RAMP REPORT REGION 2 ADA 2026

Lawerence St., & Ingraham Lane,
Rockland

CR09038

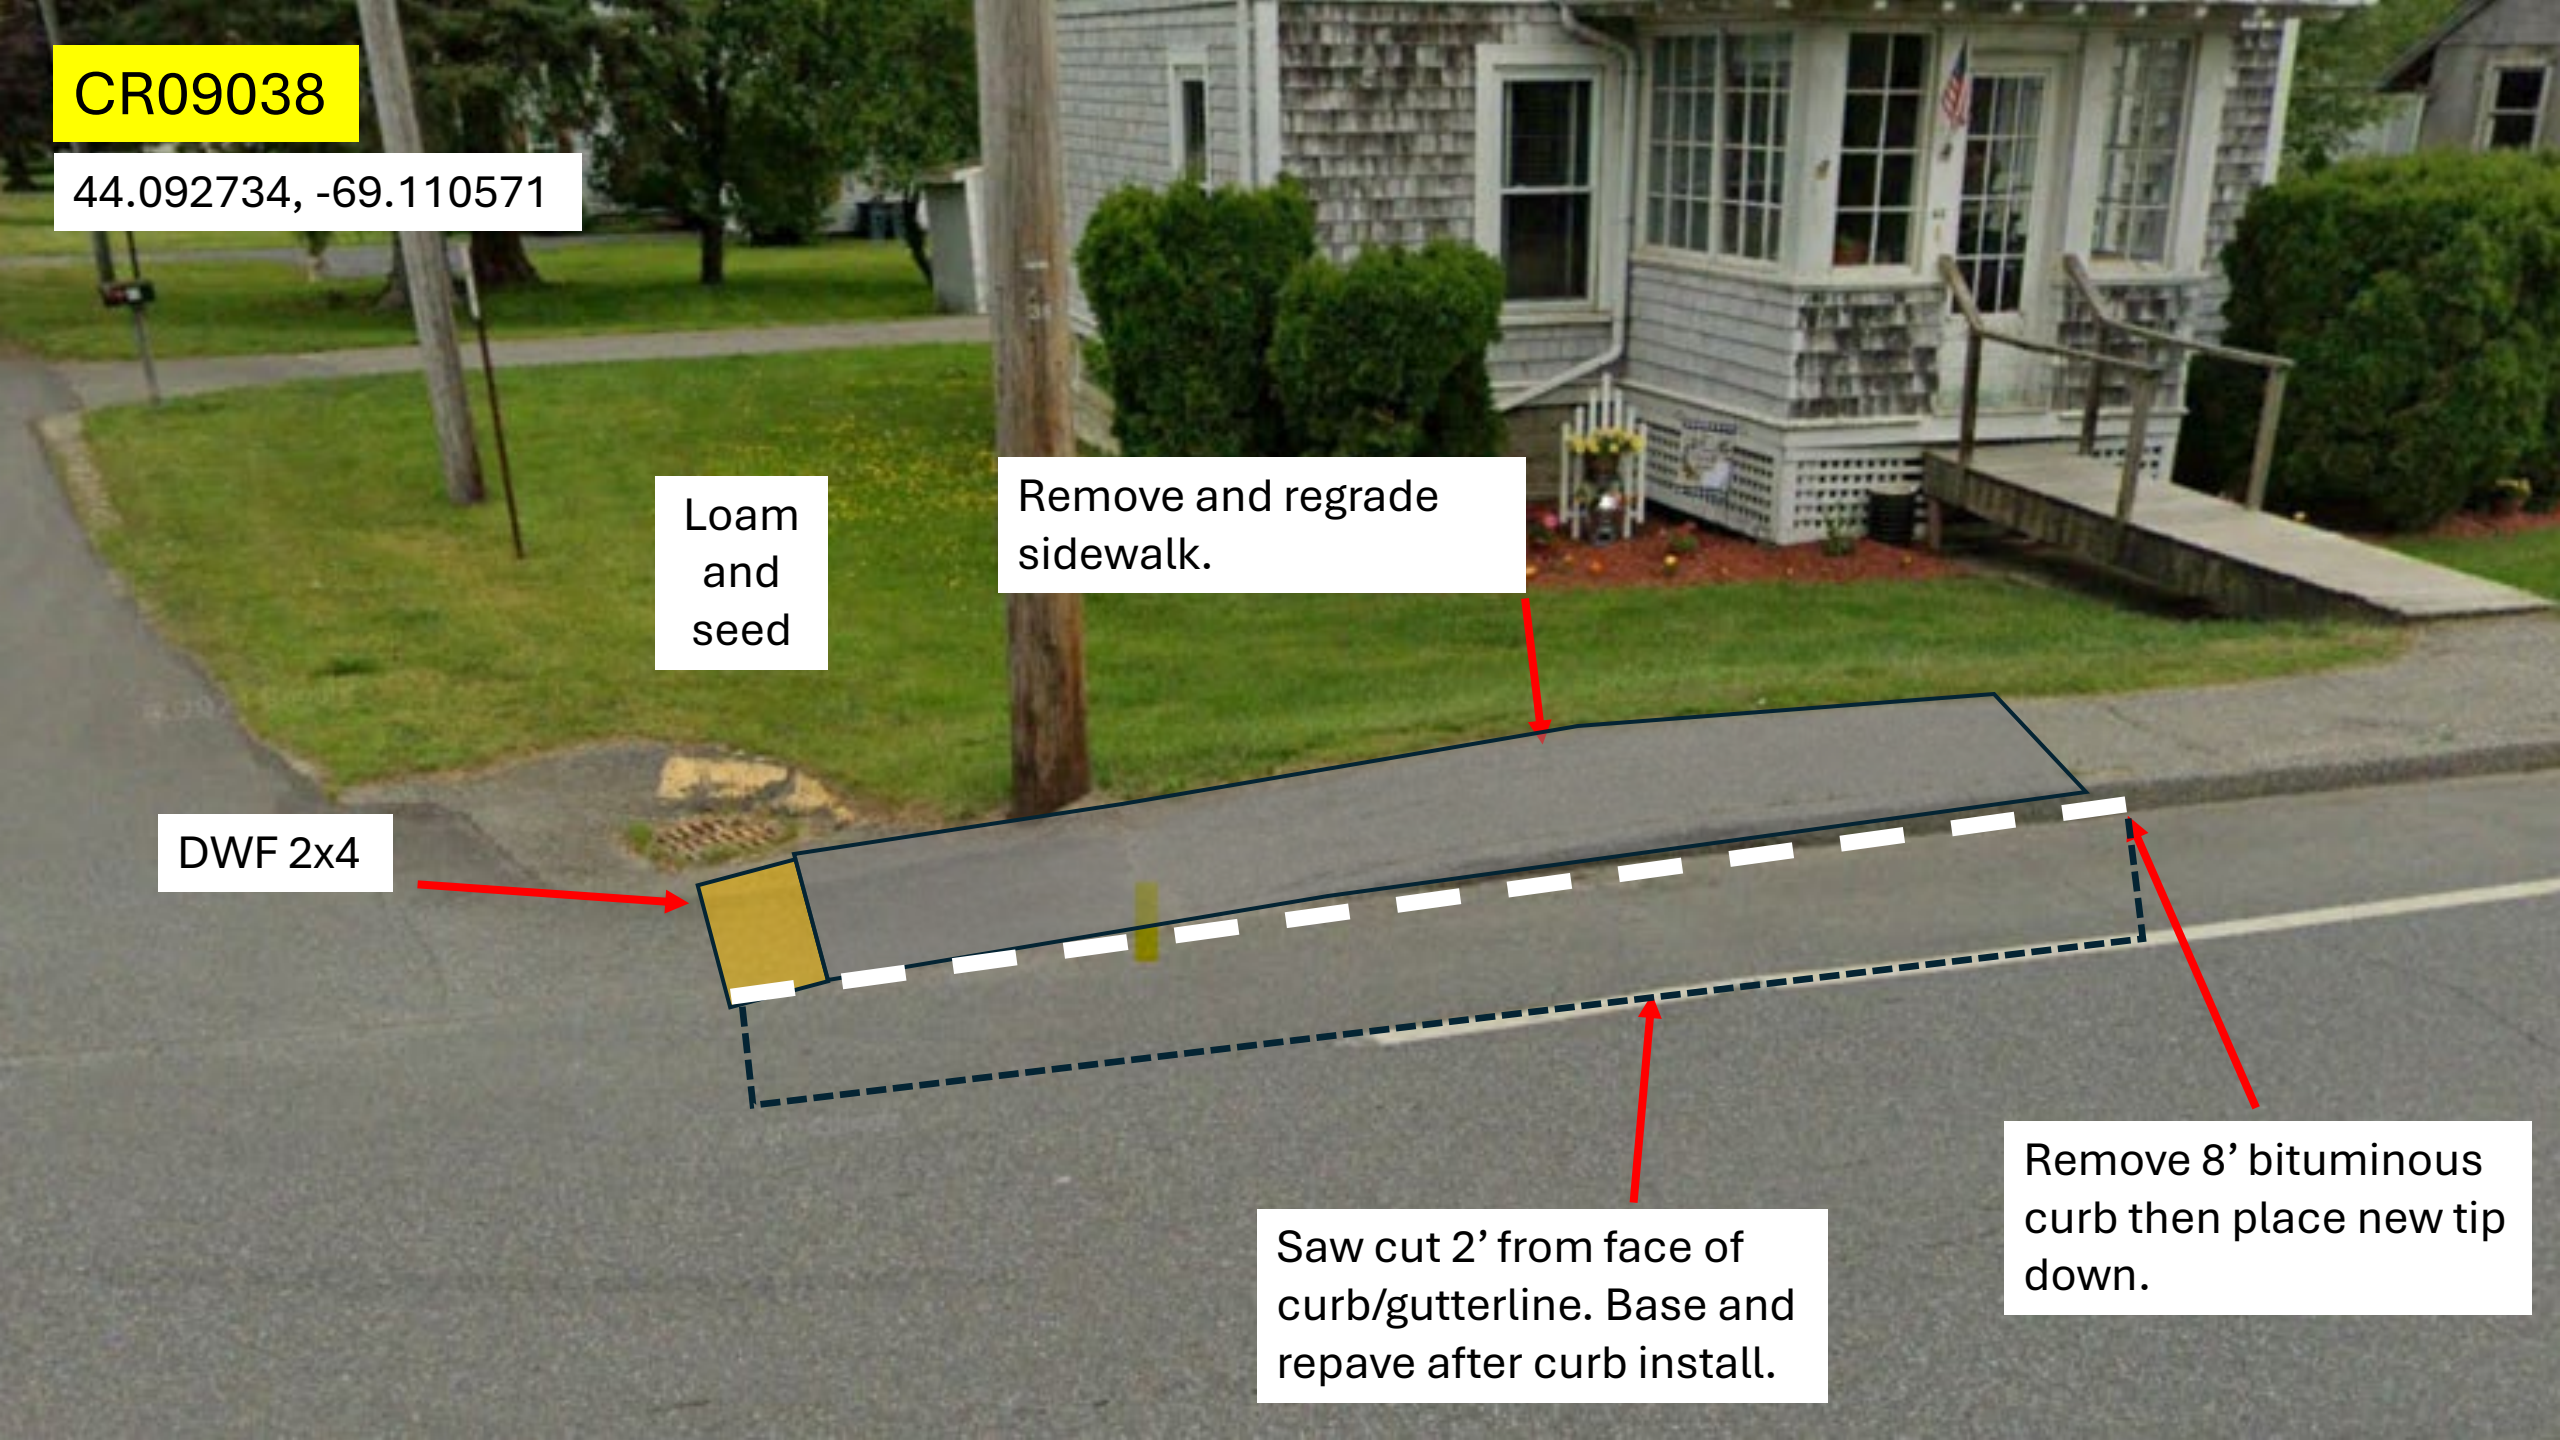
Loam
and
seed

Remove and regrade
sidewalk.

DWF 2x4

Remove 8' bituminous
curb then place new tip
down.

Saw cut 2' from face of
curb/gutterline. Base and
repave after curb install.

CR09039

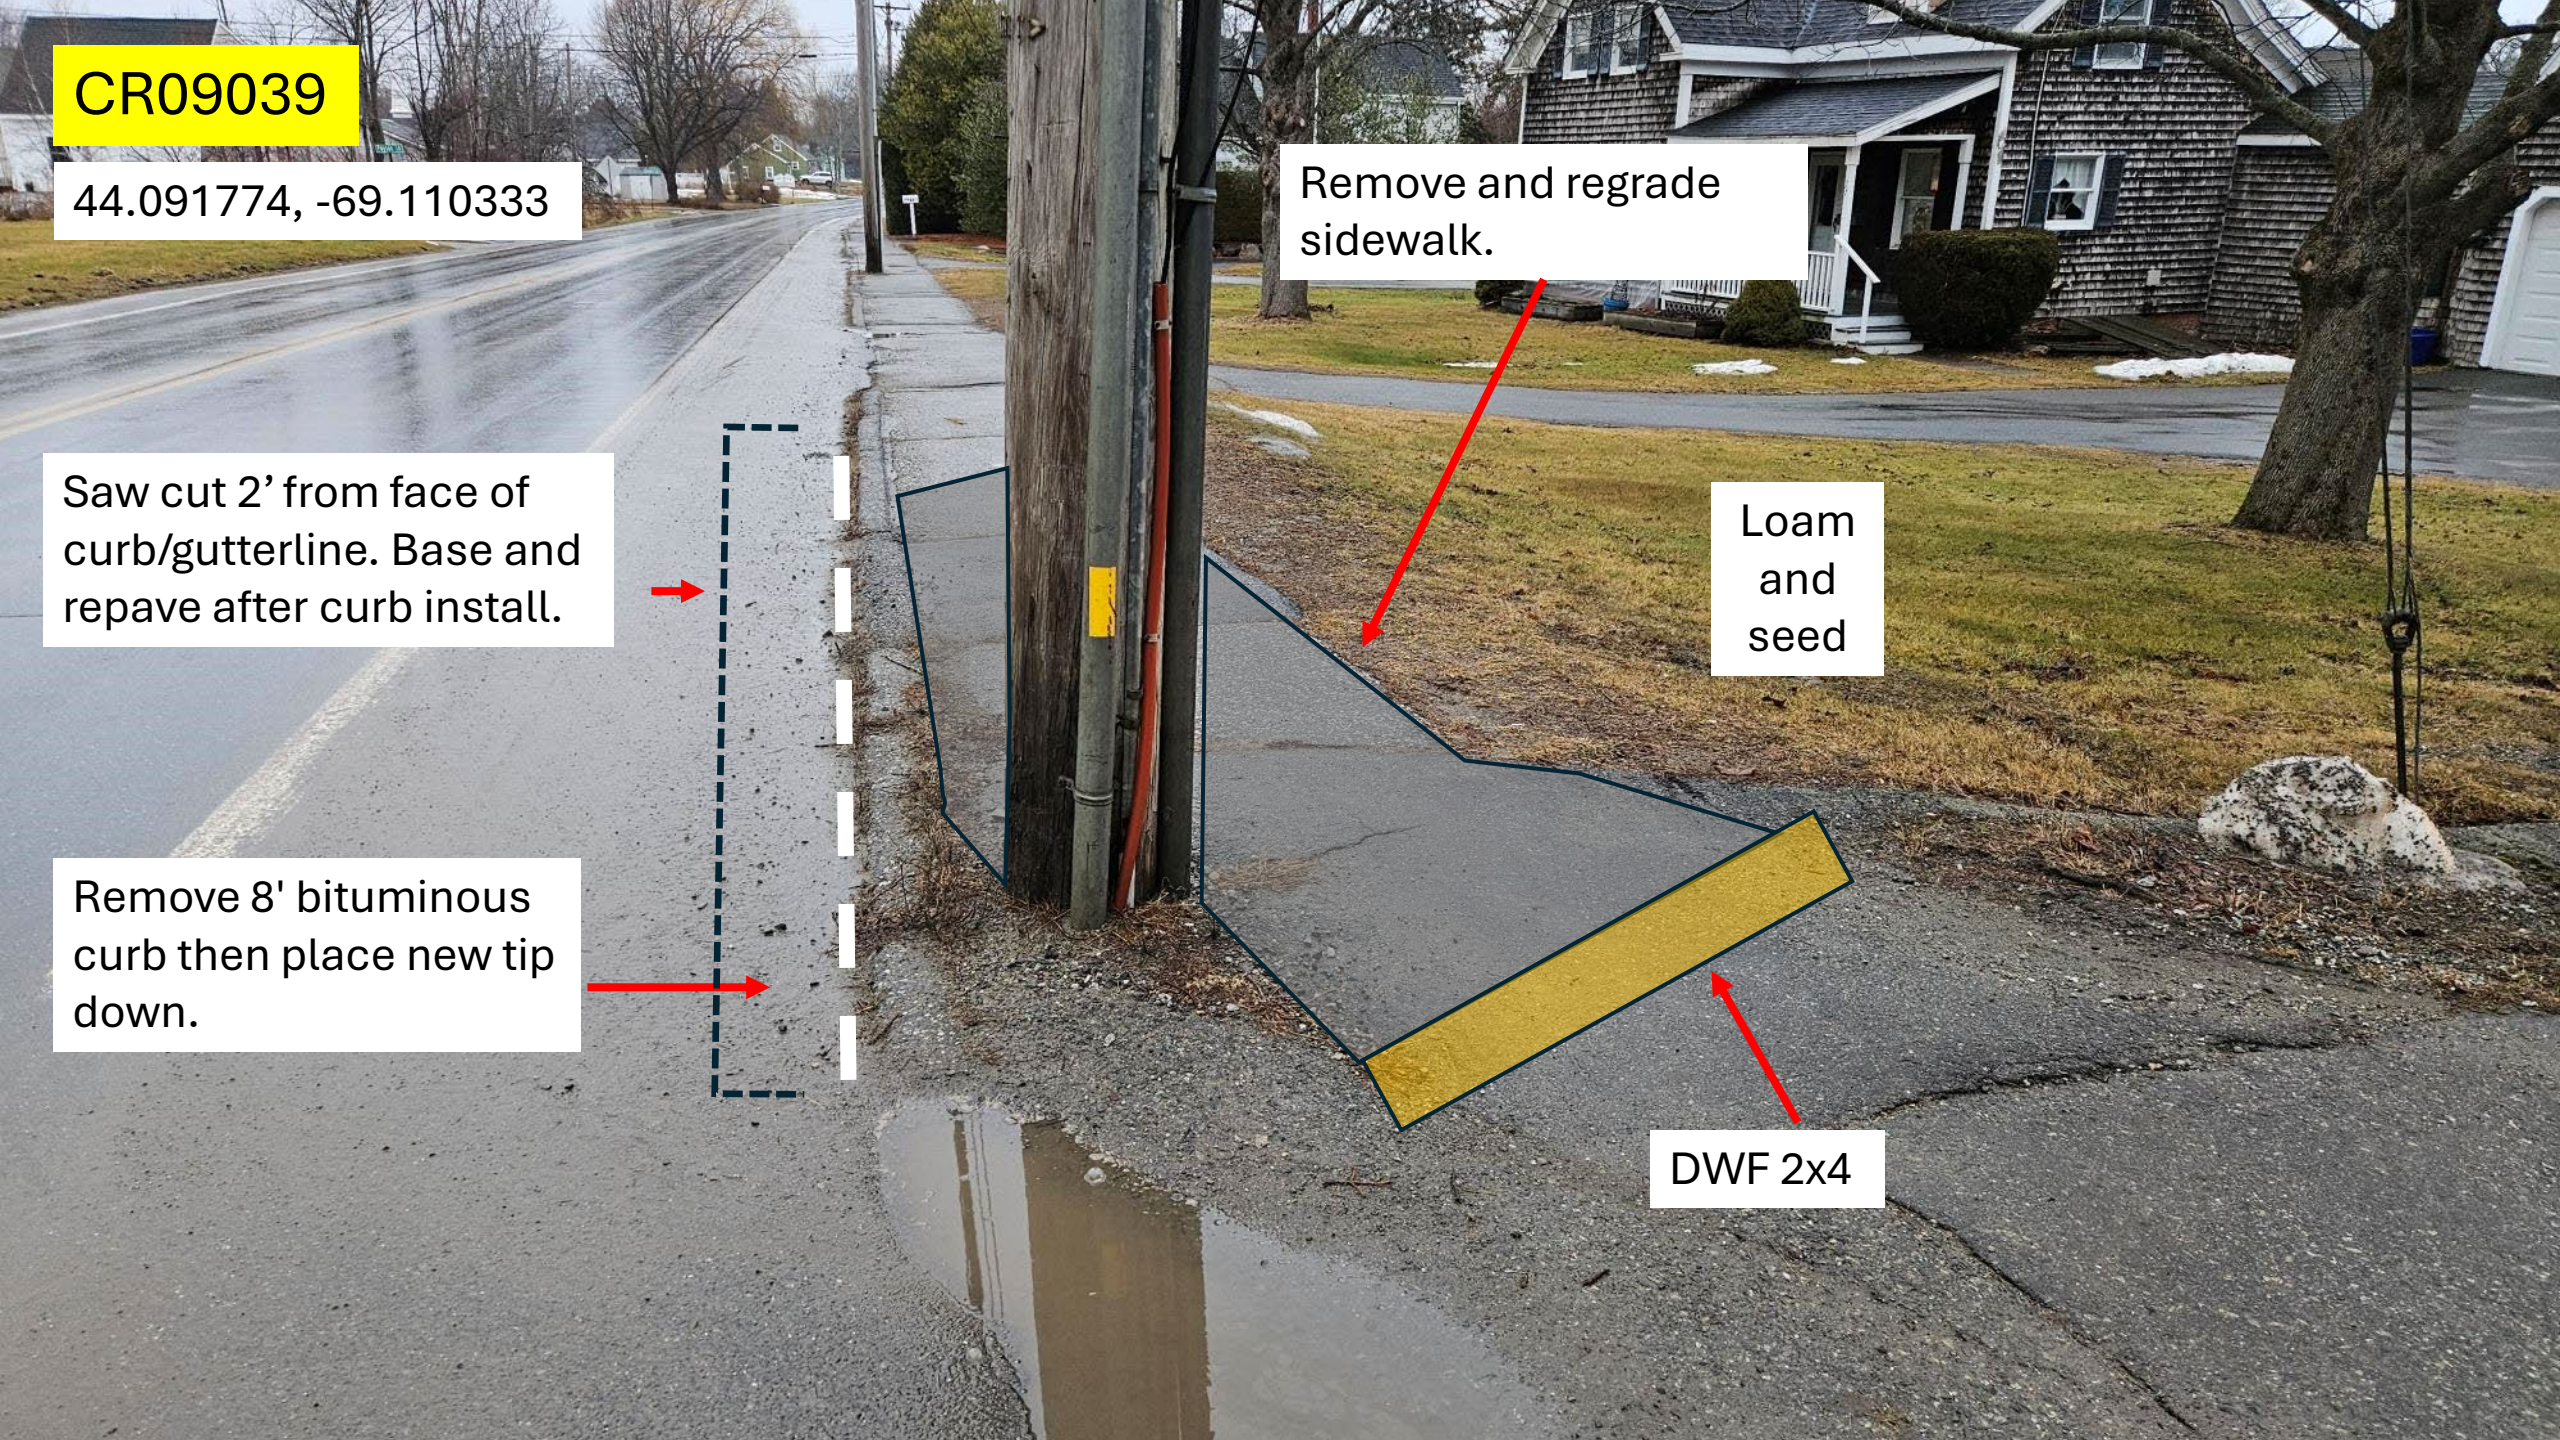
Saw cut 2' from face of curb/gutterline. Base and repave after curb install.

Remove 8' bituminous curb then place new tip down.

Remove and regrade sidewalk.

Loam and seed

DWF 2x4

CR09040

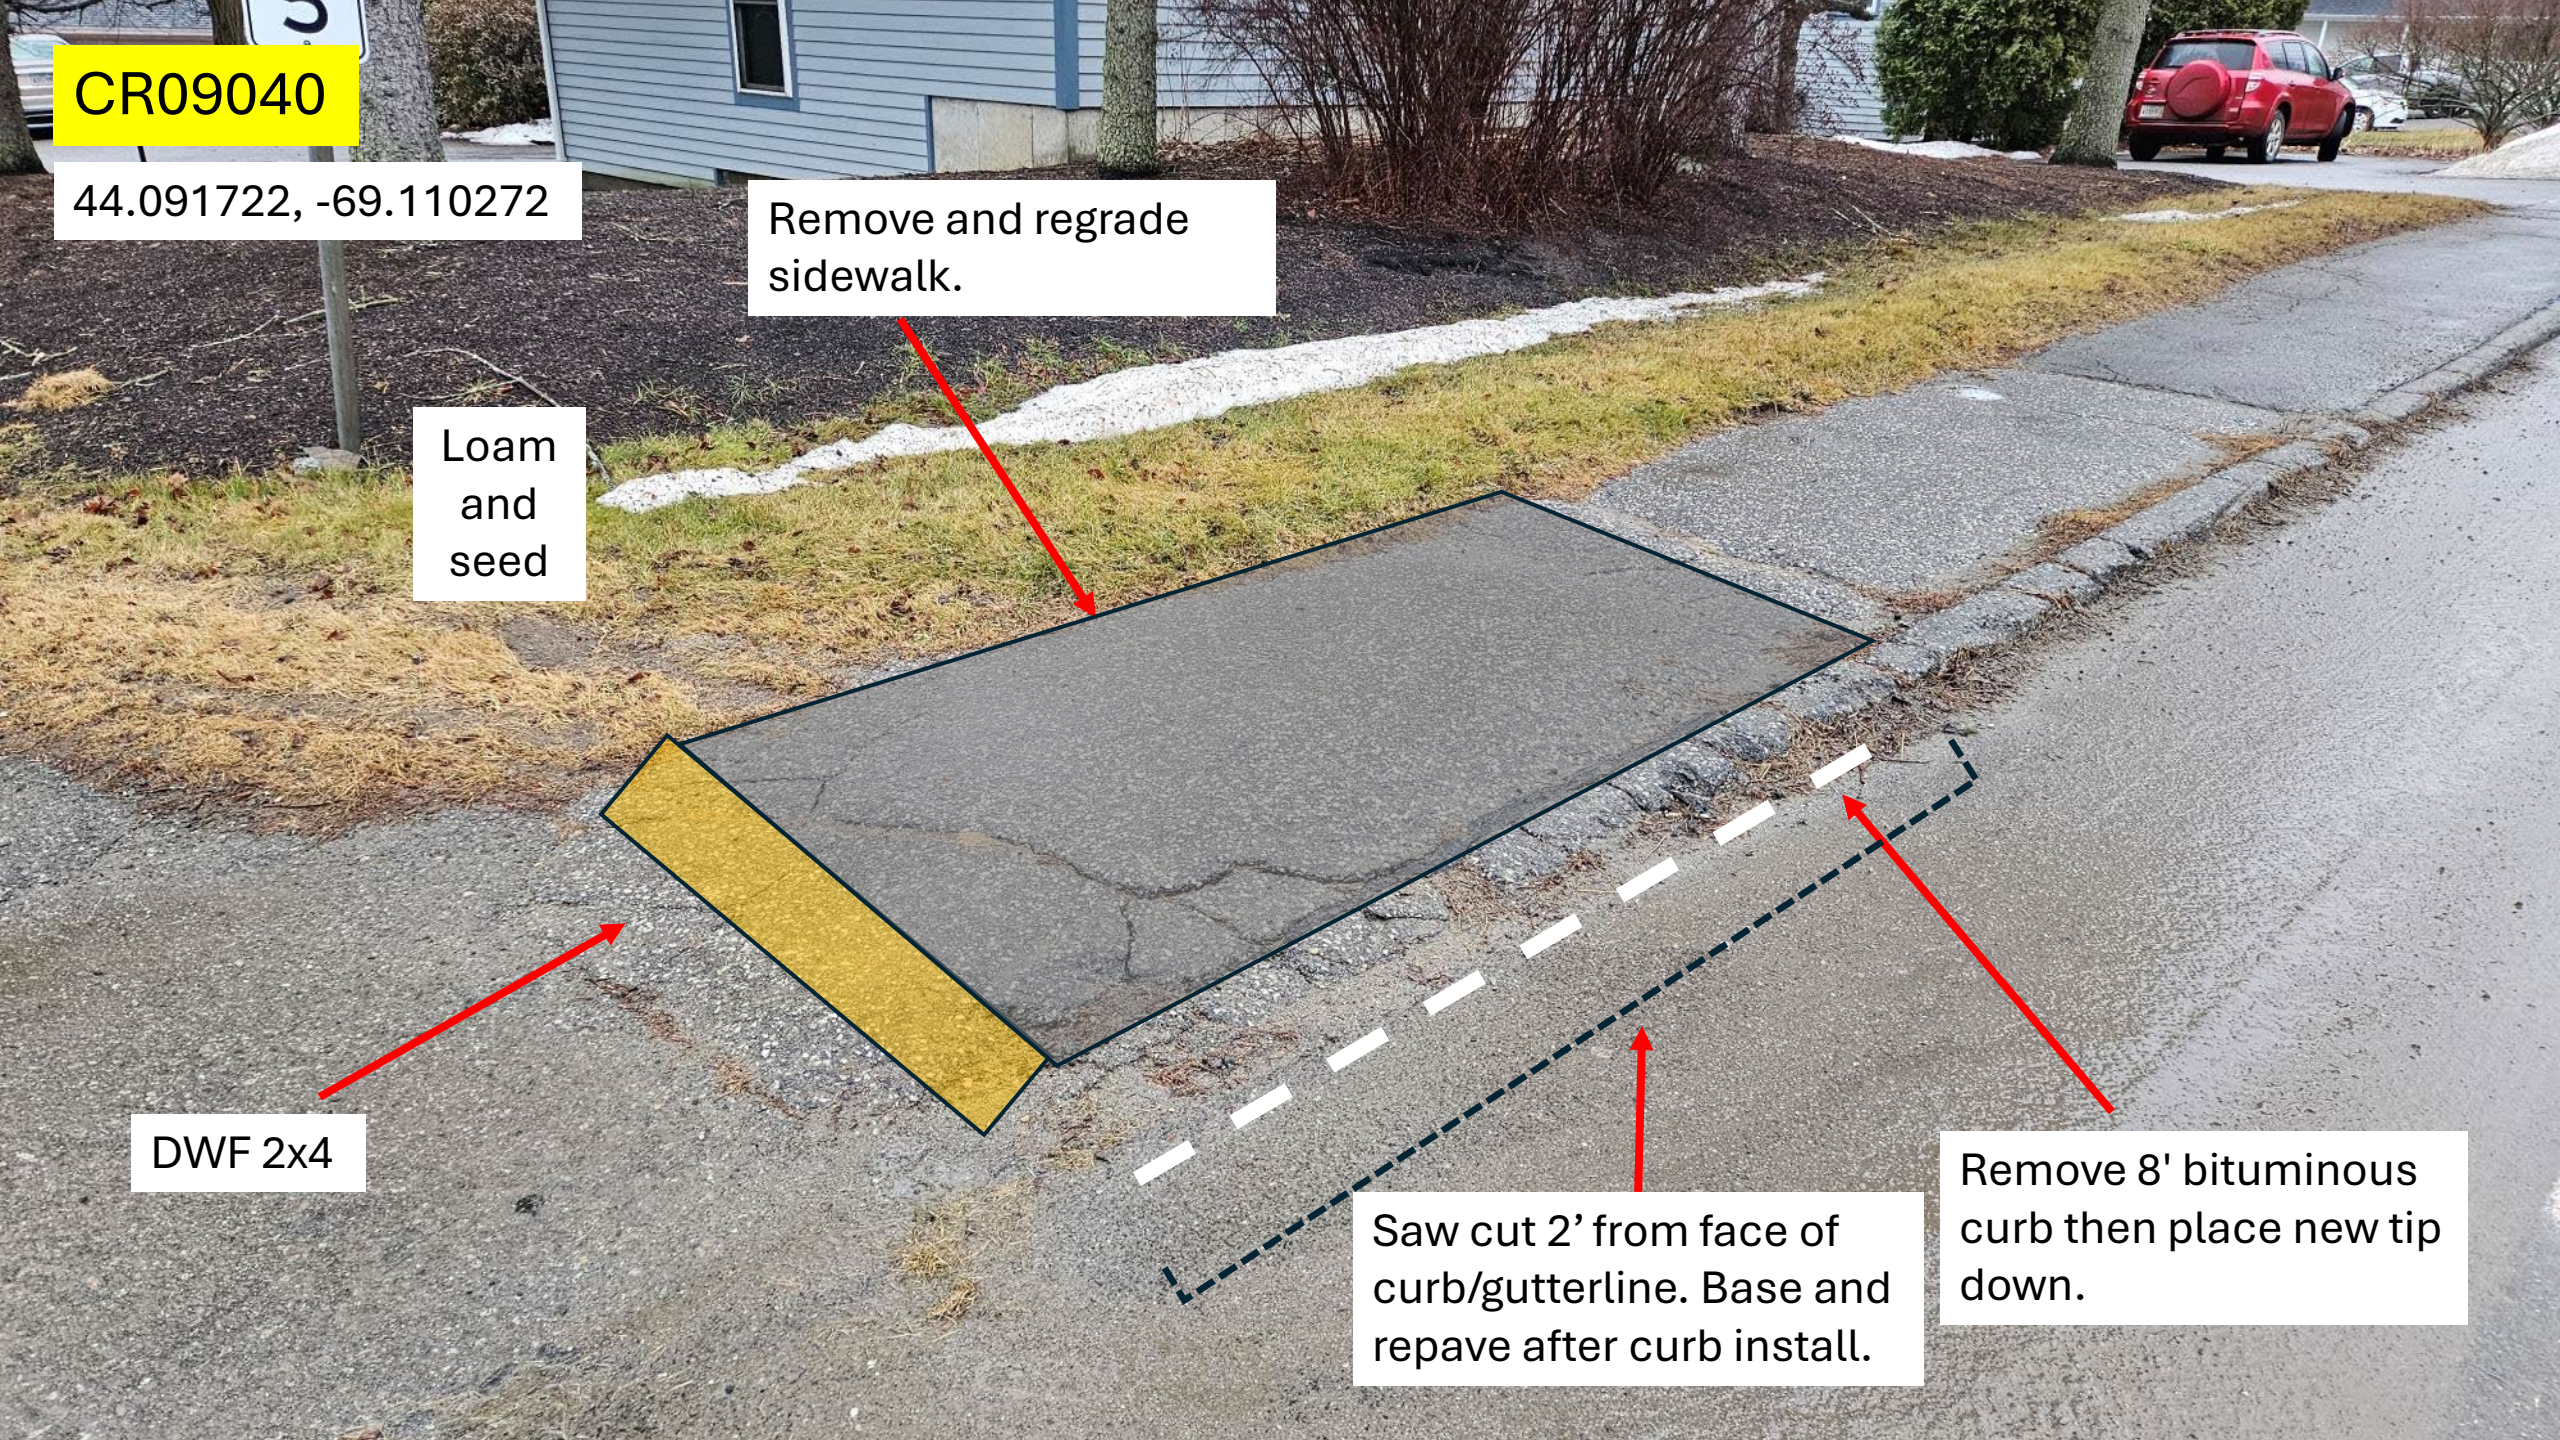
Remove and regrade sidewalk.

Loam
and
seed

DWF 2x4

Saw cut 2' from face of
curb/gutterline. Base and
repave after curb install.

Remove 8' bituminous
curb then place new tip
down.
